**TECHNOLOGY PLAN**  
SCALE: 1/8" = 1'-0"

**IT 101**

New Classroom Addition for  
**North Duplin Jr.-Sr. High School**  
1388 NC-403, Mt Olive, NC 28365  
Duplin County / North Carolina

No.	Date	Revision
3	10/18/23	ADDENDUM # 3
2	10/17/23	ADDENDUM # 2
1	10/04/23	ADDENDUM # 1

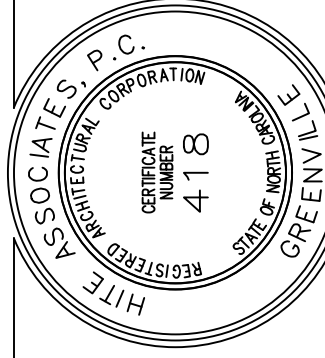
ROUTE NEW 2" RIGID METAL CONDUIT ON TOP OF CANOPY FROM ATTIC PLATFORM IN NEW BUILDING TO ABOVE CEILING IN THE EXISTING 100 WING. EXTEND INTERCOM CABLES AND DATA FIBER OPTIC LINE TO INDICATED SERVICE POINTS IN 100 WING.

APPROX. LOC. OF EXISTING INTERCOM CONSOLE. FIELD VERIFY EXACT LOC.

APPROX. LOC. OF EXISTING MAIN DATA RACK. FIELD VERIFY EXACT LOC.
